NOTICE OF MEETING

A meeting of the **ARGYLL AND BUTE LOCAL REVIEW BODY** will be held in the **COUNCIL CHAMBER, KILMORY, LOCHGILPHEAD** on **THURSDAY, 19 MAY 2011** at **2:30 PM**, which you are requested to attend.

1. **APOLOGIES FOR ABSENCE**
2. **DECLARATIONS OF INTEREST (IF ANY)**
3. **CONSIDER NOTICE OF REVIEW: 140 EDWARD STREET, DUNOON, PA23 7PH**
 - (a) Notice of Review and Supporting Documents (Pages 1 - 20)
 - (b) Response from Interested Party (Pages 21 - 44)

140 Edward Street Dunoon Application No. 10/01623/PP

drawing no. 893/894.CPA
 scale: 1/500
 date: May'10

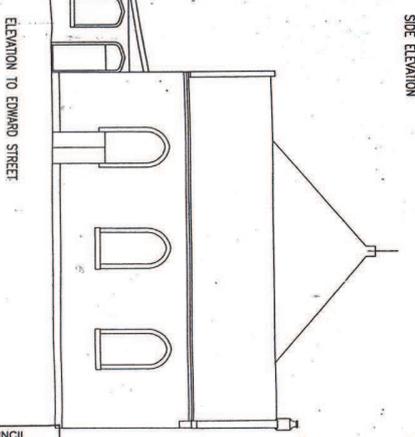
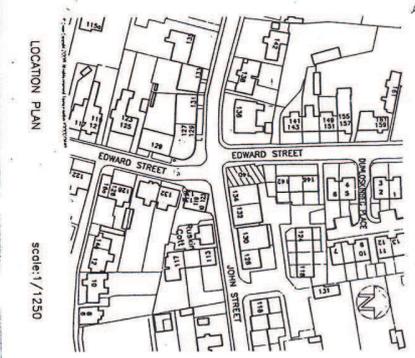
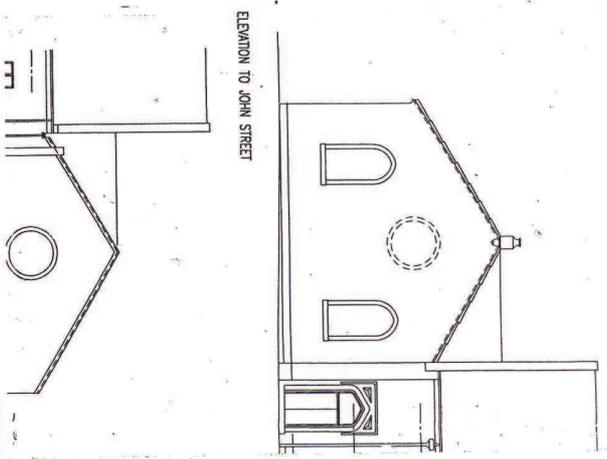
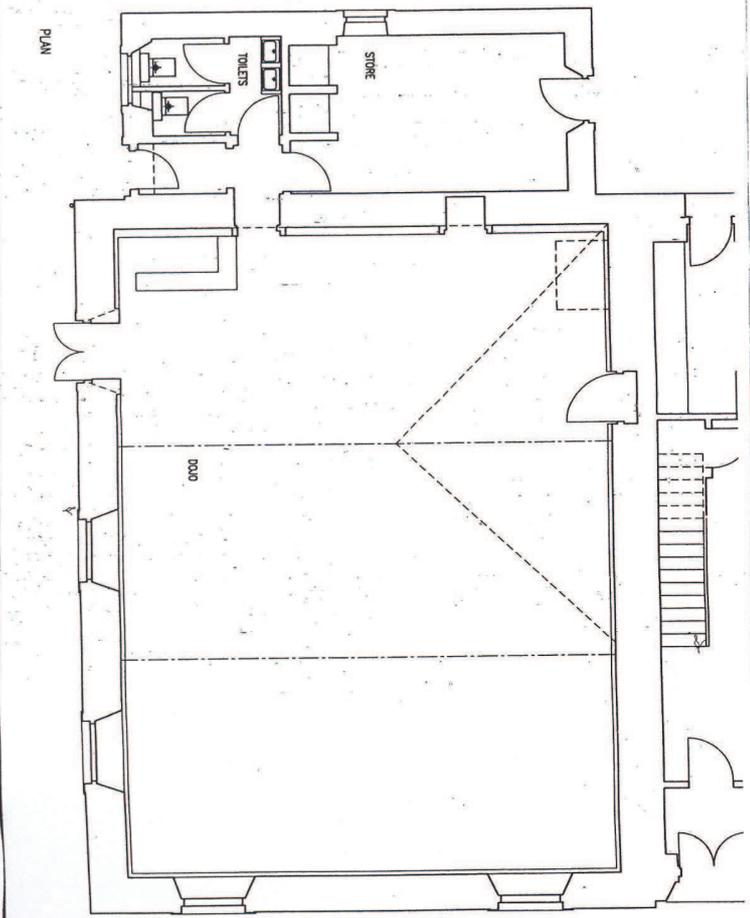
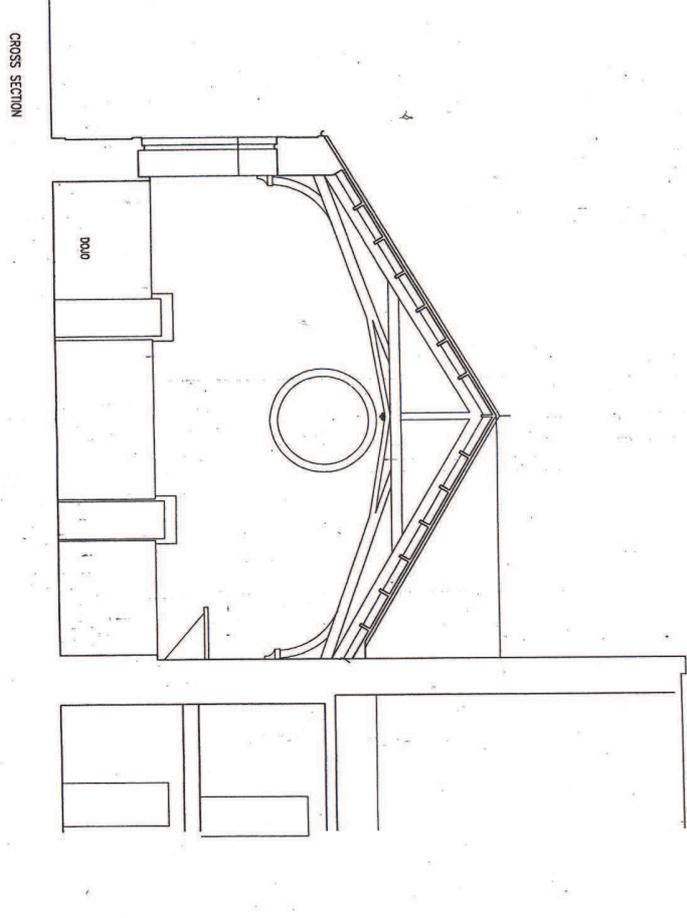
Additionally, Roads require the requisite number of car parking spaces to be 'allocated' , not 'unallocated', as proposed in the revised drawing 893/894.CPA on 29th December 2010.

Comment: As indicated above, the red line boundary (on refused drawing ref. 893/894.CPA submitted 21st December 2010) does not include the car parking spaces that are located to the rear and accessed by John Street. There is however no reason to doubt that the existing sightlines serving the ACHA housing court meet the required sightline criteria as this is an adopted road junction. The provision of two car parking spaces can only be fully assessed when these are included within the red line boundary and fully justified by ACHA that their use for the proposed flat would not have a detrimental impact on the existing car parking arrangements for all other dwellinghouses served by this car park area to the rear.

Comment: The refused drawings depict clearly an application boundary around the hall only. Any annotated notes on this drawing outwith the application site boundary have no planning status. In any event, these four car parking spaces are 'unallocated' and in use by residents as depicted in photographs (Appendix 3).

As Roads objected to this proposal due to lack of car parking and an unsafe parking space, revised drawings were submitted on 21st December 2010 (ref. 893/894.CPA and 894.02 Rev A) that omitted the single car parking off Edward Street but still included the red line boundary around the building only. Whilst four car parking spaces were shown outside the red line boundary, these could not be included or tied to the development.

A further revised site layout drawing (ref. 893/894.CPA) was submitted on 29th December 2010 which extended the original red line boundary to incorporate two of the four car parking spaces in the parking court to the rear. Altering the red line boundary was considered to be 'material' in nature and would require the submission of a fresh application to be assessed on its individual merits. Please note that we now have two different proposals on drawings both numbered 893/894.CPA.

The department can determine the application as originally submitted (i.e. and including 'non-material' revisions accepted under drawings ref. 893/894.CPA and 894.02 Rev A submitted on 21st December 2010) but cannot consider the revised proposals submitted on 29th December 2010 as these would require to be the subject of a fresh application that would be considered on its individual merits. Please confirm by no later than 9th February whether your client wishes this application to be determined as explained above or withdrawn.
